Access Compliance Report

Public Rights-of-Way

Intersection ID: 5264	Main Street: BEATTIES_FORD_RD	Cross Street: MCINTYRE_AV	Location: NE
ADA ID: 8DB445B2AF6C	Ramp Type: Perpendicular Diagonal	Initial Pass/Fail: Pass	Overall Compliance: No
Severity Score: 1.25			
Codes/Mitigation Info/Possible Solution		Field Measurements/Component Compliance

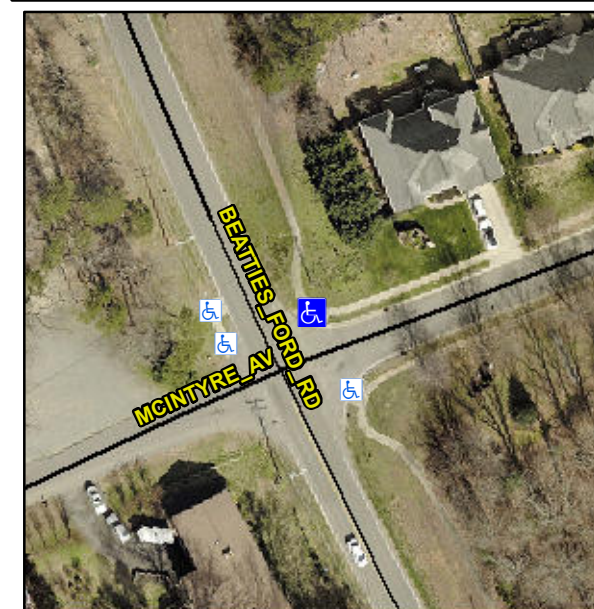
Remove & Replace Curb Ramp With Two New Directional Ramps or Equivalent. Remove & Replace Gutter.

R304.5.1, R304.2.1, R304.5.4, R304.5.3
